The Commission has issued the enclosed Amendment No. 24 to Facility Operating License No. DPR-31 and Amendment No. 23 to Facility Operating License No. DPR-41 for the Turkey Point Nuclear Generating Units Nos. 3 and 4. The amendments consist of changes to the Technical Specifications in response to your application dated May 21, 1976.

TURKEY POINT NUCLEAR GENERATING UNIT NO. 3

Amendment No. 24
License No. DPR-31

SAFETY EVALUATION BY THE OFFICE OF NUCLEAR REACTOR REGULATION

Figure B3.1-1

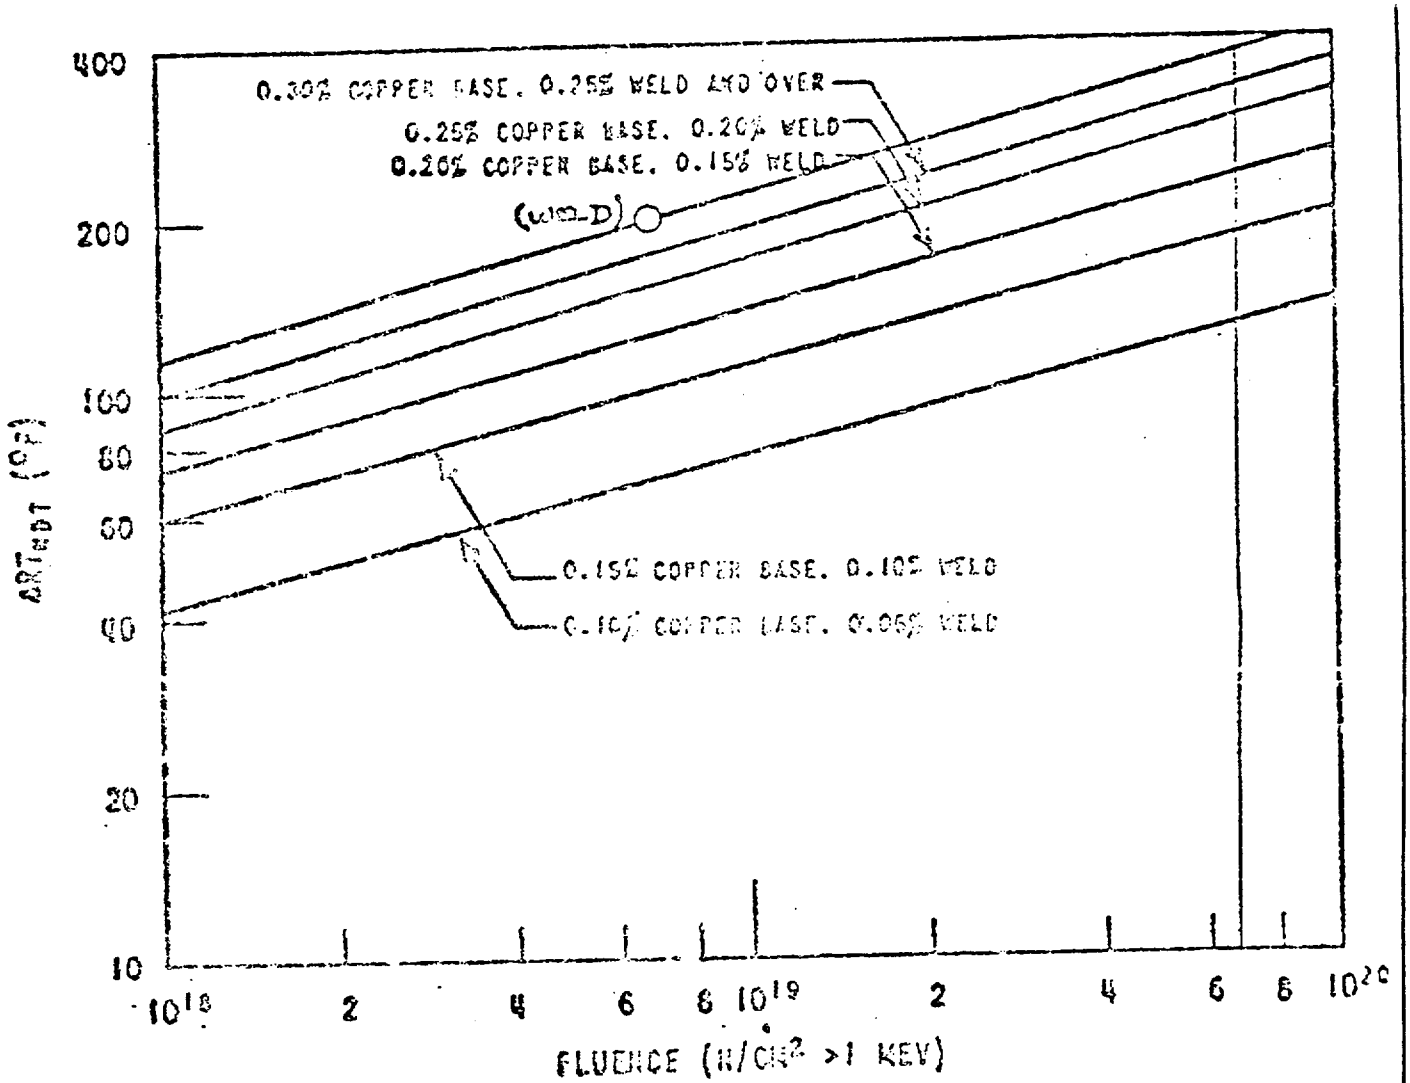
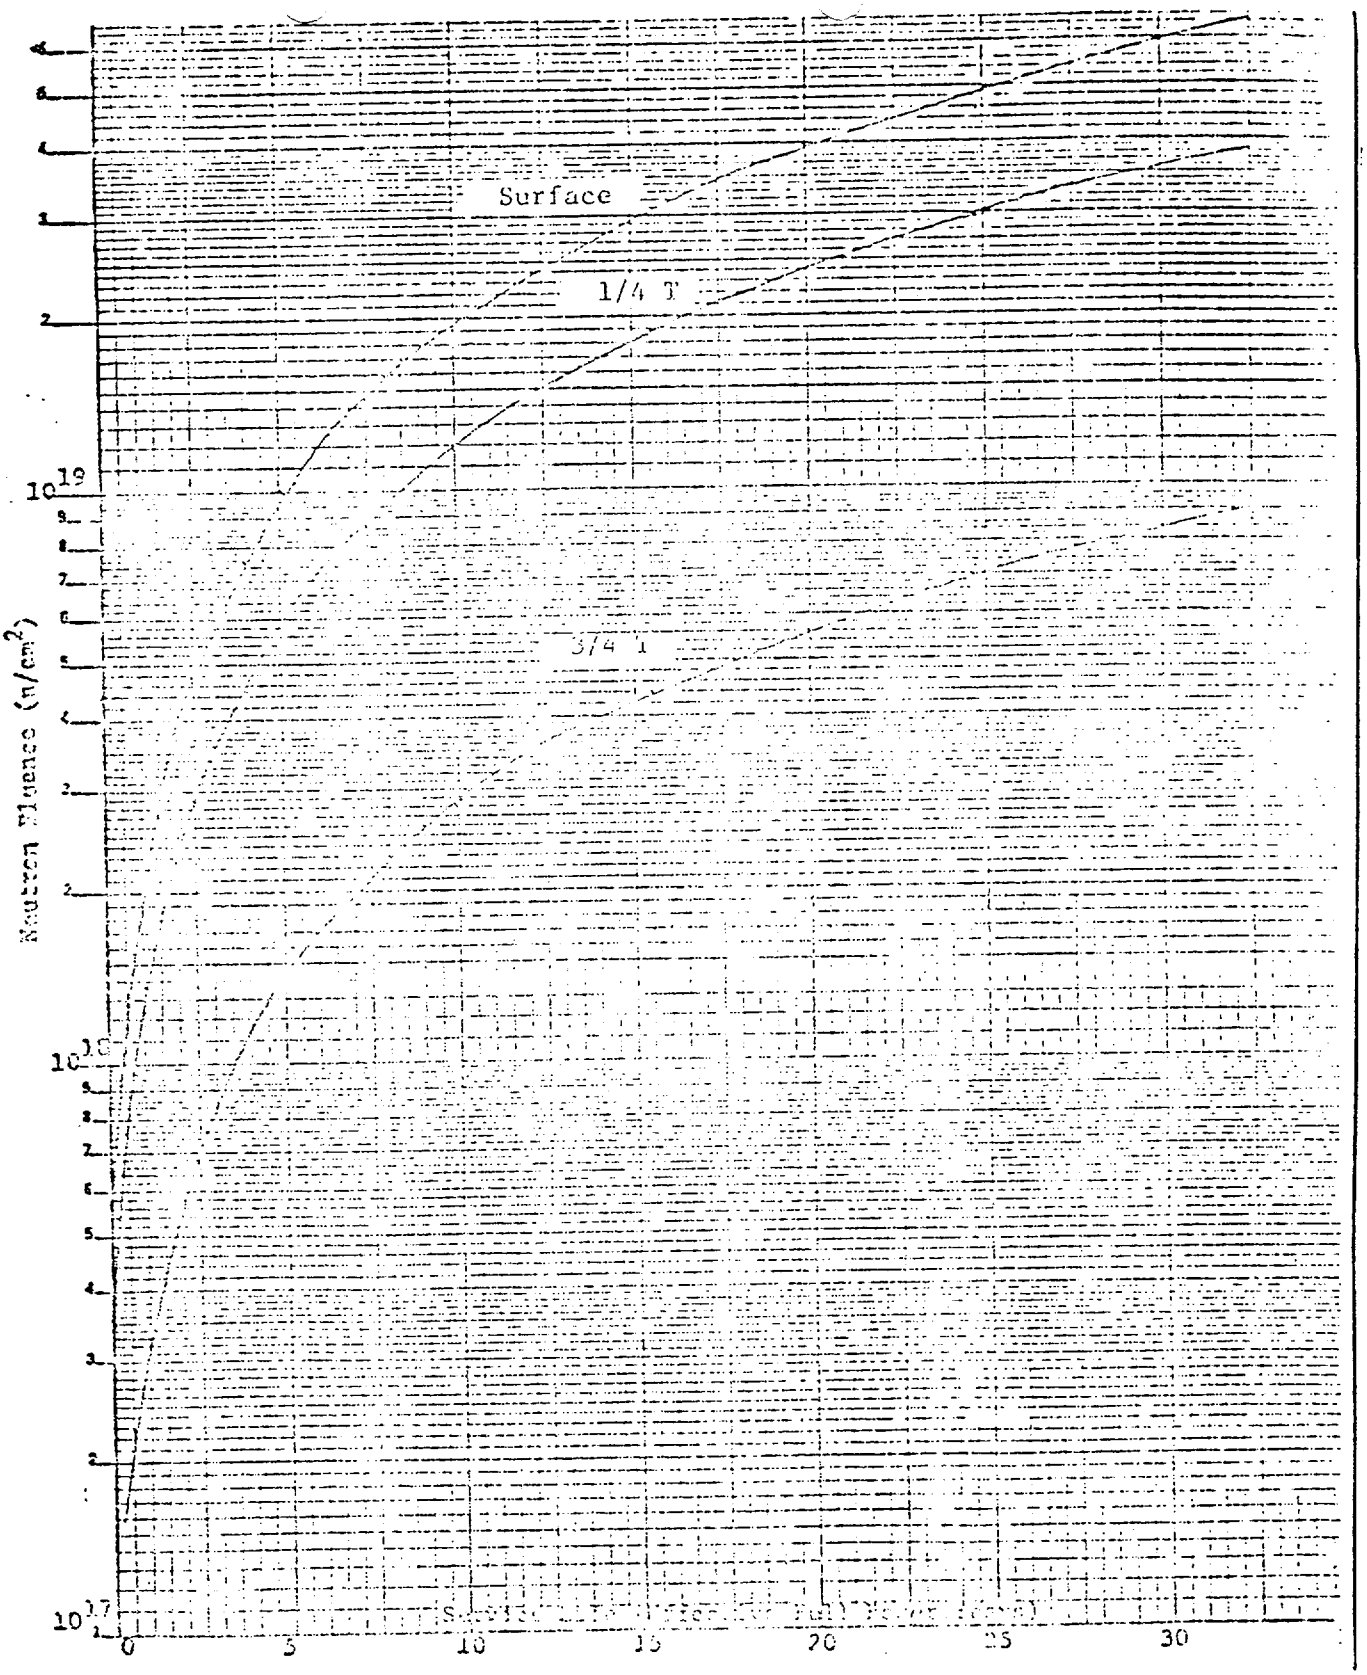
Replace pages i, v, 3.1-2 thru 3.1-4, and B3.1-1 thru B3.1-4 with the attached revised pages. Replace Figure 3.1-1 with Figures 3.1-1a and 3.1-1b. Add Figures B3.1-1 and B3.1-2.

The reactor vessel materials have been tested to determine their initial RT_{NDT}. Adjusted reference temperatures, based upon the fluence and copper content of the material in question, are then determined. The heatup and cooldown limit curves include the shift in RT_{NDT} at the end of the service period shown on the heatup and cooldown curves.
